MEMORANDUM

SUBJECT: Seismic Evaluation, NGL #C12, API # 123-41201

SUBJECT: Need for Seismic Evaluation

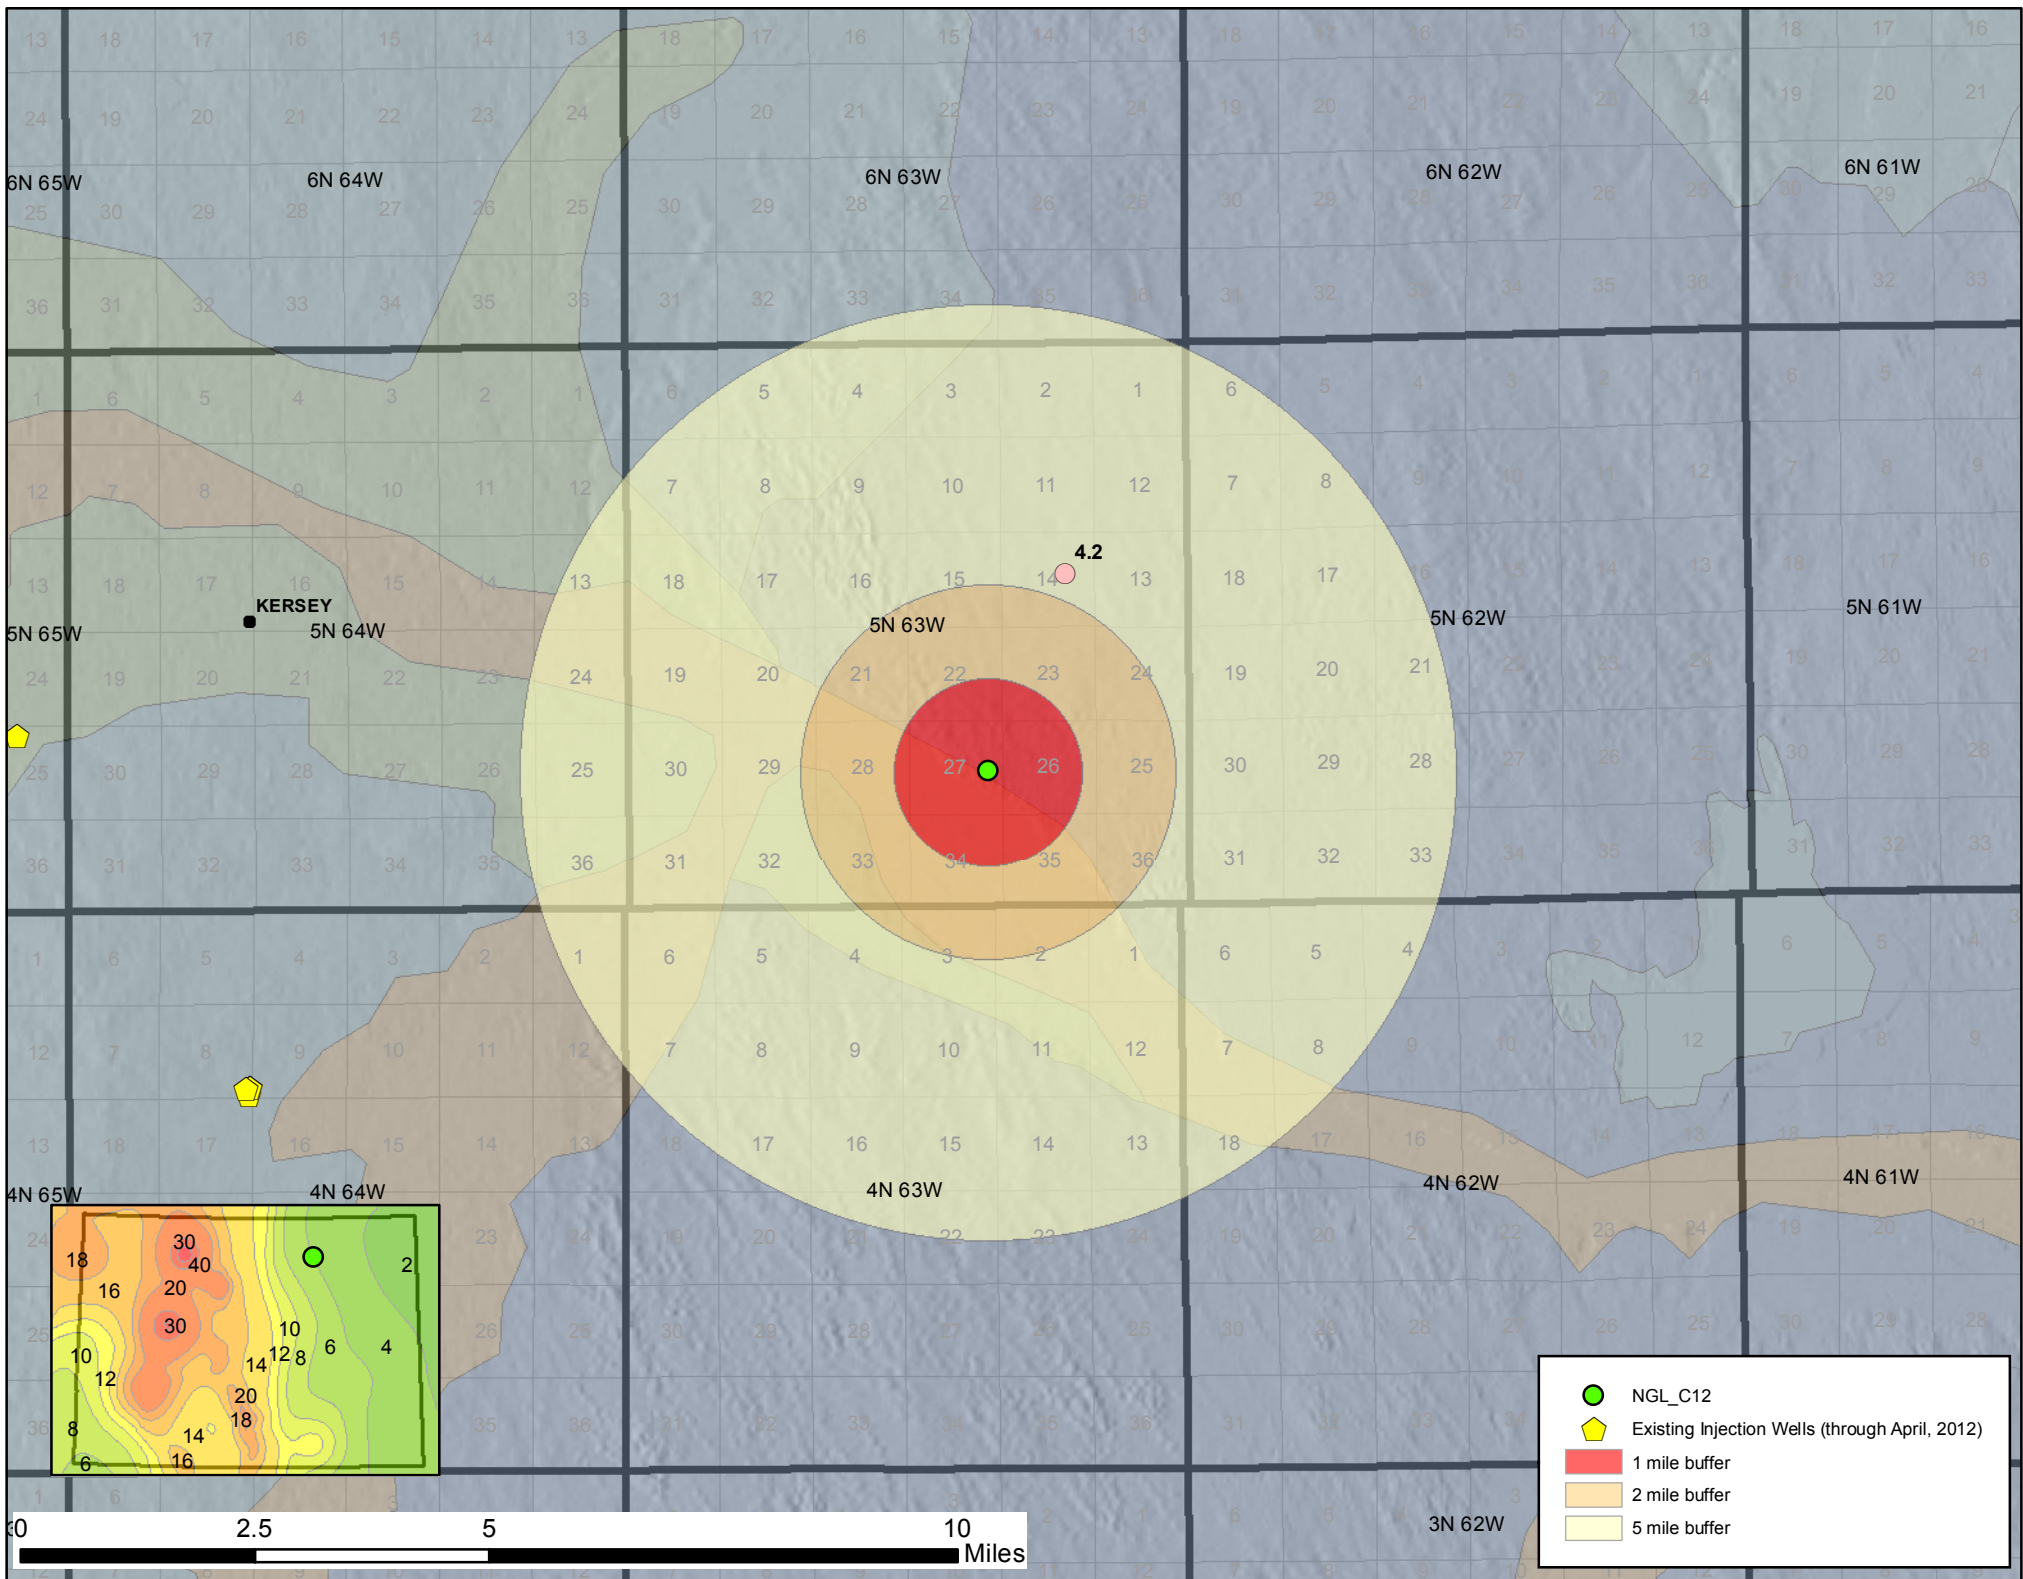
The USGS National Earthquake Hazard Map shows areas susceptible to ground shaking during fifty year intervals. This part of Colorado is an area that has been designated as being susceptible to a lower PGA (~0.07 g) compared with other parts of Colorado.
